Site Audit Report

PFAS Material Emplacement Area (PFAS MEA), Former Schofields Aerodrome, off Mariner Avenue, Schofields, NSW 2762
MP169_01

22 June 2021

Figure 7: Inferred Groundwater Elevation (Ramboll 2017)
PFAS Validation Report - Former Schofields Aerodrome

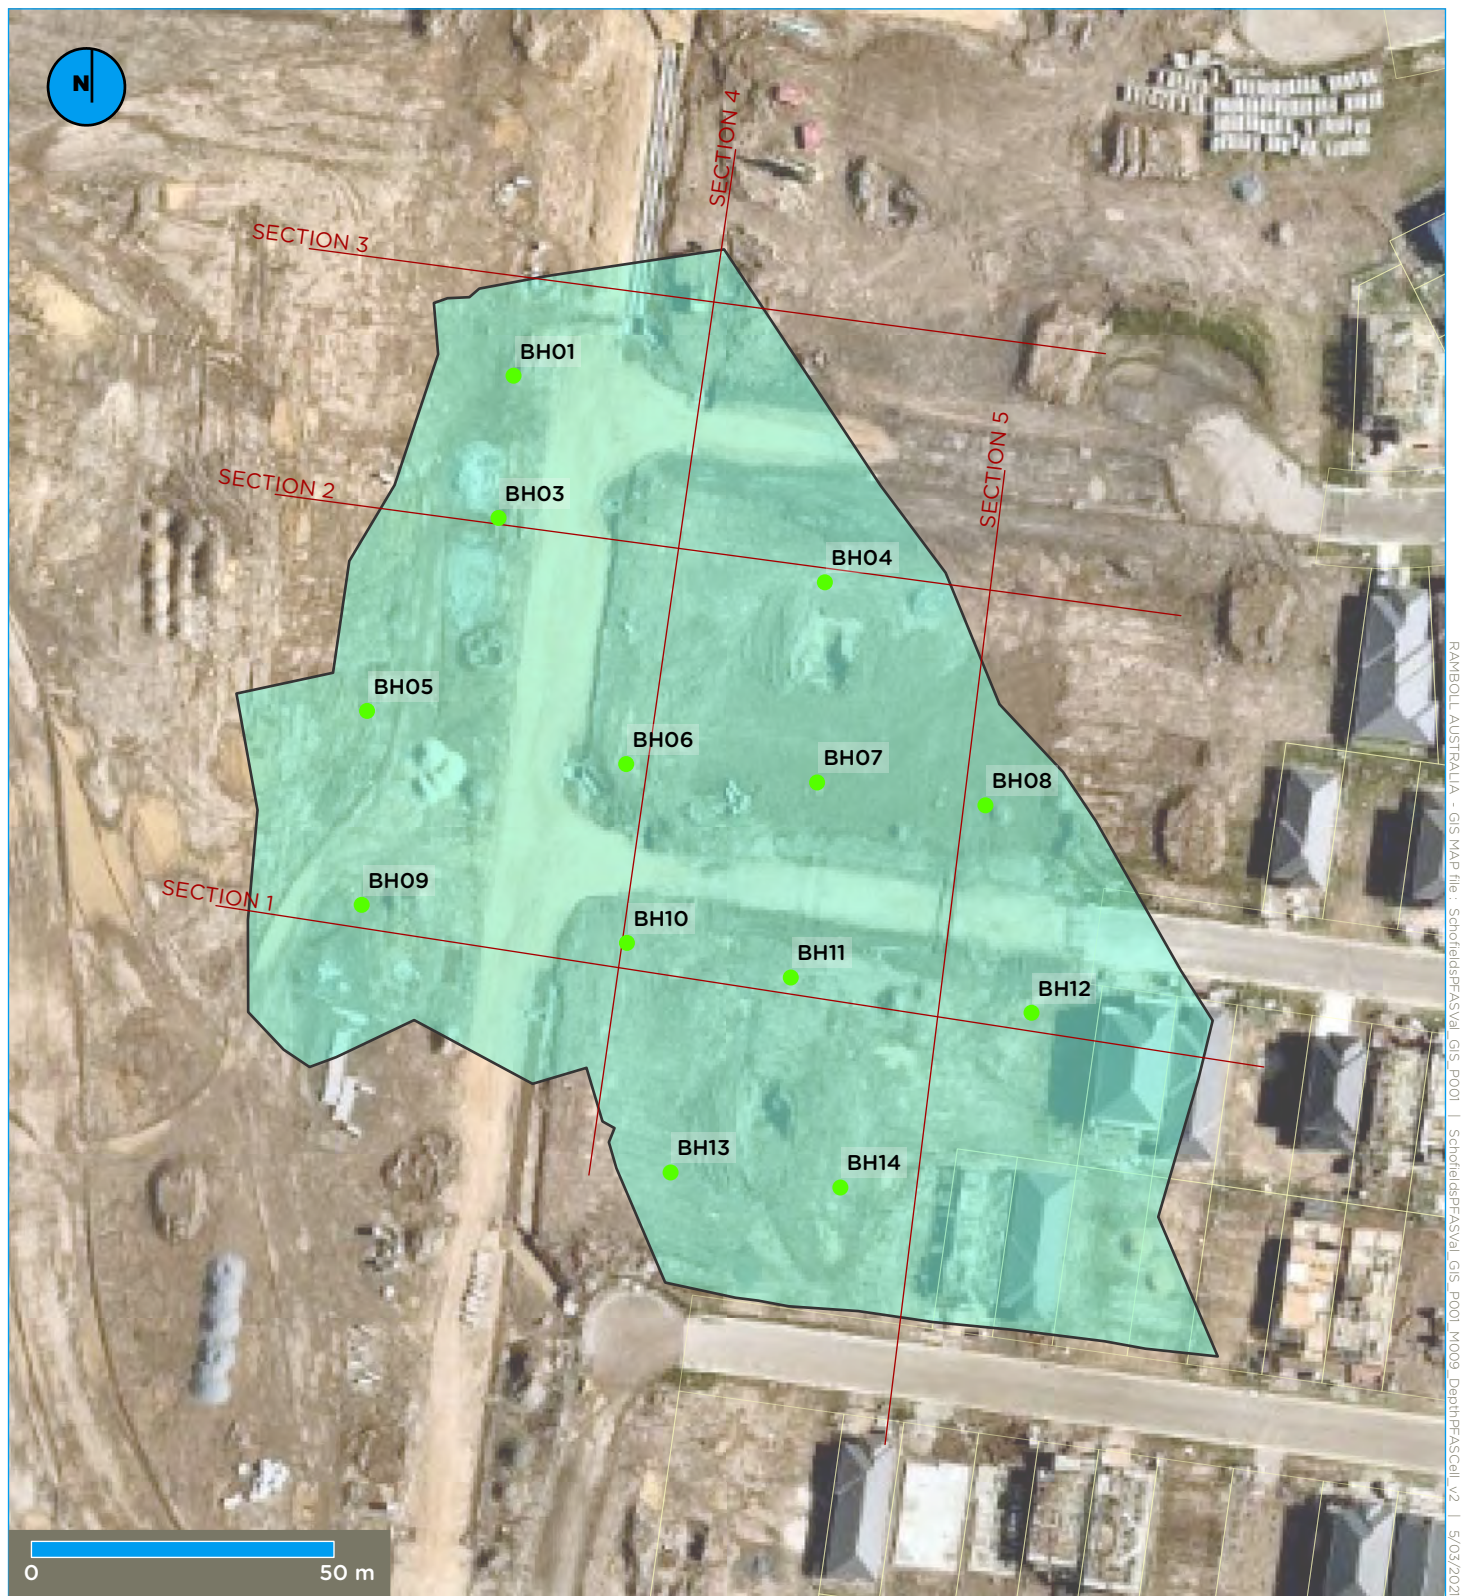
7. Section 10.1.2 states that the highest groundwater elevations observed across the three GMEs (2017) were used to approximate the groundwater standing water level for the PFAS MEA. This is inconsistent with Figure 7 which does not adopt the highest SWL measured at BH107. The approximate standing water levels in Table 10-1 are not the most conservative scenario based on the available data.
